Appendix B-1
Proposed Amendments to the Diesel Test Procedures

**CALIFORNIA EXHAUST EMISSION STANDARDS AND
TEST PROCEDURES
FOR 2004 AND SUBSEQUENT MODEL
HEAVY-DUTY DIESEL ENGINES AND VEHICLES**

State of California
AIR RESOURCES BOARD

Date of Release: June 23, 2020
Date of Hearing: August 27, 2020

Figure CA26-1: Alternative Durability Demonstration Using Accelerated Aftertreatment Aging

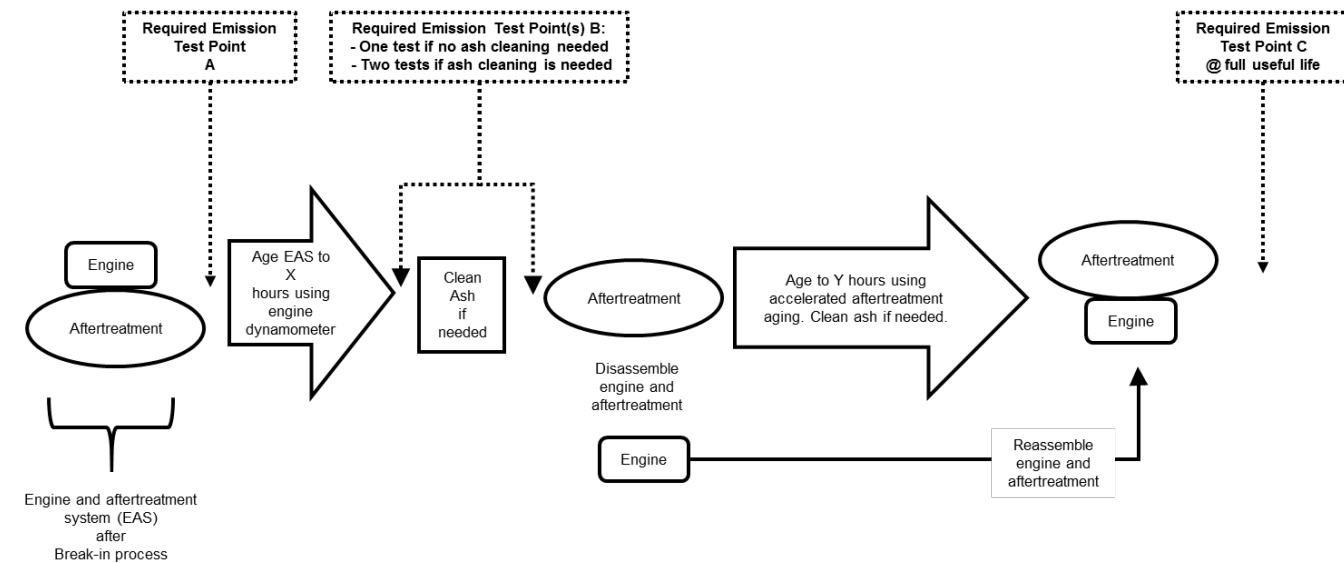
1.1.1.4.2 Option 2: 4,900 hours of service accumulation on an engine dynamometer, followed by accelerated aftertreatment aging for ½ of useful life, as shown in Figure CA26-1 below. This alternative durability demonstration program reduces the total hours of durability demonstration by allowing manufacturers to use accelerated aftertreatment aging for 50% of the useful life.

1.1.1.4.2.1 Manufacturers selecting Option 2 must perform at least four emissions tests (if ash cleaning is required), or three emissions tests (if no ash cleaning is required) using the applicable certification cycles (FTP, RMC and LLC) cycles to calculate deterioration factors. The emissions test intervals are shown in Figure CA26-1 as emission test points A, B and C.

Figure CA26-2: Cycle-1 Service Accumulation Cycle

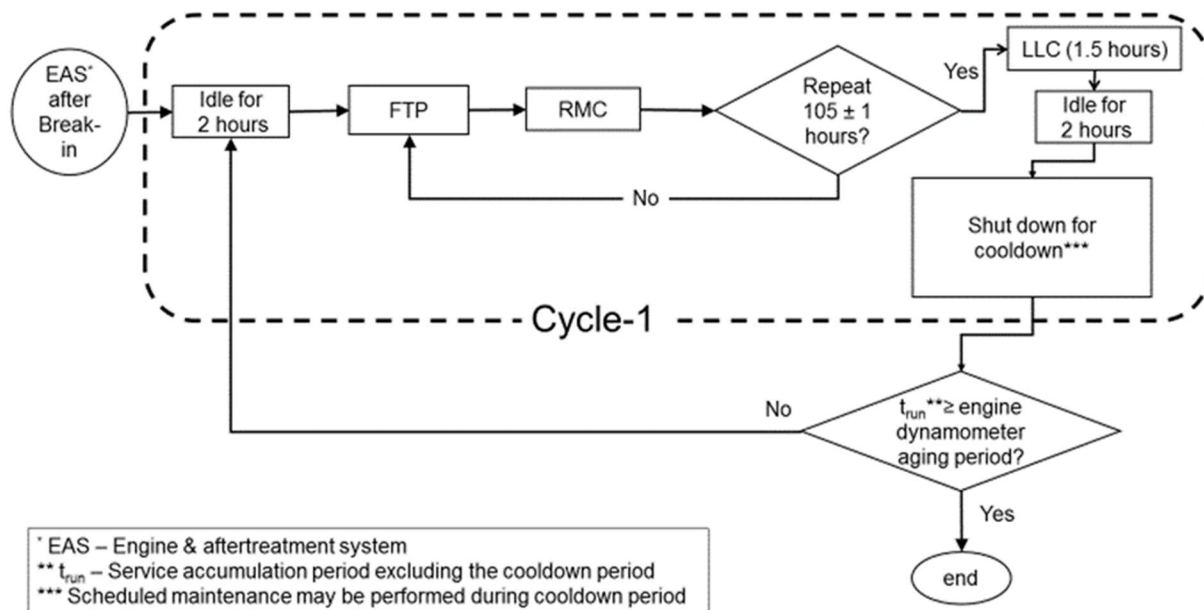
1.1.1.5.1 Cycle-1 – A combination of the FTP, RMC, LLC and extended idle periods as specified in Figure CA26-2.

Figure CA26-3: Cycle-2 Service Accumulation Cycle

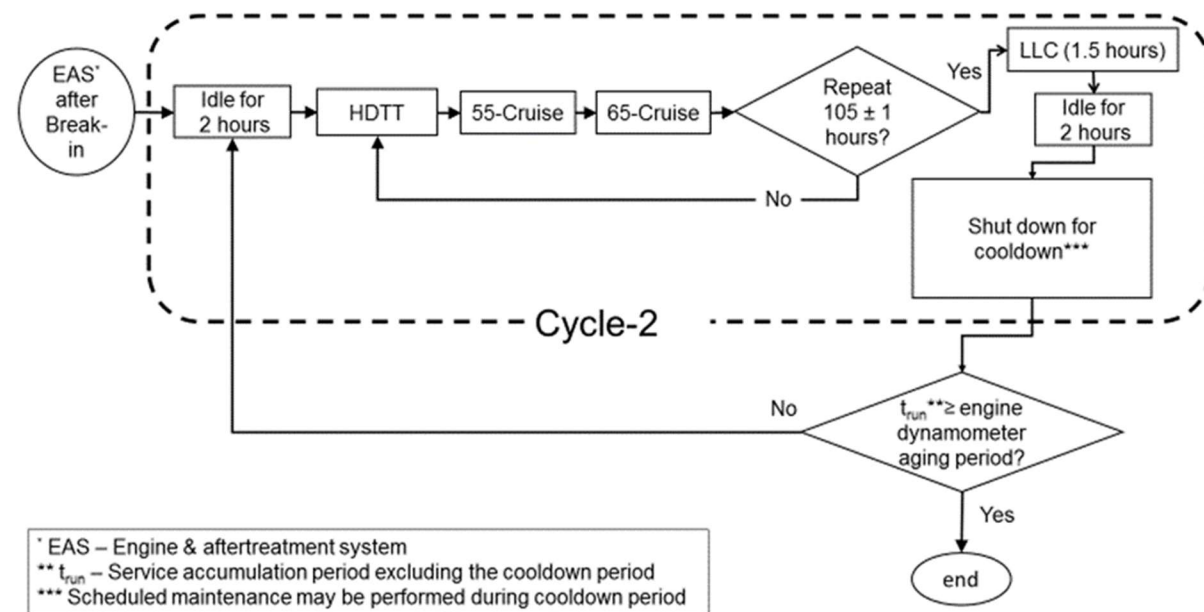
1.1.1.5.2 Cycle-2 – A combination of HDTT, 55-cruise, 65-cruise, LLC and extended idle periods as specified in Figure CA26-3. The manufacturer must consider all possible greenhouse gas vehicle subcategories as defined in 40 CFR §1037.230, last amended Oct. 25, 2016, which is incorporated by reference herein. For each engine family, the manufacturer must choose the vehicle subcategory and vehicle configuration that yields the highest load factor using the GEM model. Manufacturers may use a 20-second ramp-up or ramp-down period in between the HDTT, 55-cruise and 65-cruise cycles. Engine manufacturers that do not have access to vehicle configuration parameters for the applicable engine family, may use vehicle design parameters used in the GEM model (as specified in 40 CFR §1037.520, last amended October 25, 2016, which is incorporated by reference herein) from previous model year engine families in the same primary intended service class and applications.

Figure CA26-4: Alternative Durability Demonstration Using Accelerated Aftertreatment Aging for 2027 and Subsequent Model Year Heavy Heavy-Duty Engines

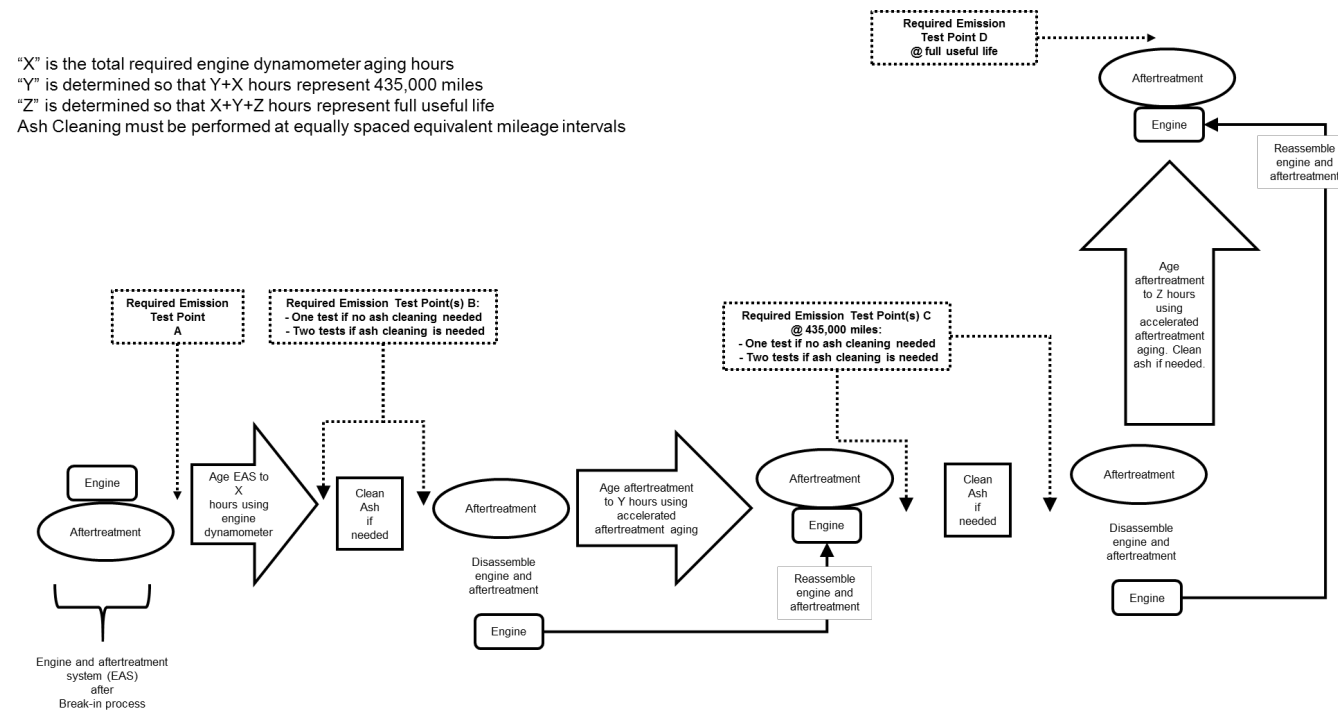
1.1.2 For 2027 and subsequent model year engine families, manufacturers shall develop a durability demonstration program using a combination of dynamometer aging, accelerated aftertreatment aging and in-use emissions reporting using the provisions in subparagraph B.1.1.3 of this section and good engineering judgement. Manufacturers must additionally meet the requirements in subparagraphs B.1.1.1.5 through B.1.1.1.7 of this section. For light heavy-duty and medium heavy-duty engines, the sequence of the aging process and the required emission test points are shown in Figure CA26-1. For heavy heavy-duty engines, the sequence of the aging process and the required emission test points are shown in Figure CA26-4. The following schedules establish minimum required service accumulation for each primary intended service class:
